Access Compliance Report

Public Rights-of-Way

(Curb Ramps)

Intersection ID: 10039363	Main Street: SYDENHAM_CT	Cross Street: N/A	Location: SW
ADA ID: 2481473F4FD9	Ramp Type: Perp	Initial Pass/Fail: Fail	Overall Compliance: No
Codes/Mitigation Info/Possible Solution		Field Measurements/Component Compliance	
Severity Score: 25

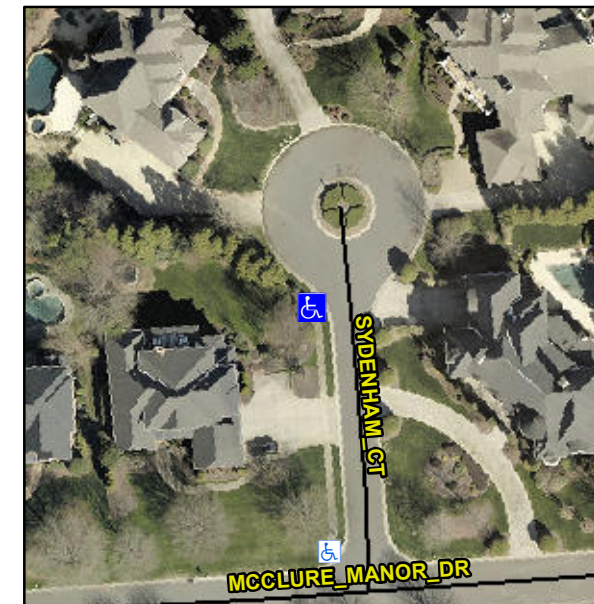
R304.2.2, R304.5.3

Compliance	Description	Data	Compliance	Description	Data
N/A	Ramp Length (in)	49.0	No	Ramp Slope (%)	9.0
Yes	Ramp Width (in)	48.0	No	Ramp XSlope (%)	6.0
N/A	Flare Type LT	N/A	N/A	Flare Type RT	N/A
N/A	Flare Slope LT (%)	N/A	N/A	Flare Slope RT (%)	N/A
N/A	Flare Traversable LT?	N/A	N/A	Flare Traversable RT?	N/A
N/A	Landing Length (in)	N/A	N/A	DWS Provided?	N/A
N/A	Landing Width (in)	N/A	N/A	DWS Contrast?	N/A
N/A	Landing Slope (%)	N/A	N/A	DWS Length (in)	N/A
N/A	Landing X Slope (%)	N/A	N/A	DWS Full Width?	N/A
N/A	Landing Curb? (Y/N)	N/A	N/A	DWS Offset (in)	N/A
N/A	Shared Landing?	N/A			
N/A	Gutter Ponding?	N/A	N/A	Gutter Slope (%)	N/A
N/A	Gutter Lip Ht (in)	N/A	N/A	Gutter X Slope (%)	N/A
N/A	Painted X Walk1?	No	N/A	Painted X Walk2?	N/A
	X Walk 1 Direction	To E		X Walk 2 Direction	N/A
N/A	X Walk 1 Width (in)	N/A	N/A	X Walk 2 Width (in)	N/A
	X Walk 1 Slope (%)	0.3		X Walk 2 Slope (%)	N/A
	X Walk 1 X Slope (%)	5.6		X Walk 2 X Slope (%)	N/A

Remove & Replace Entire Ramp.
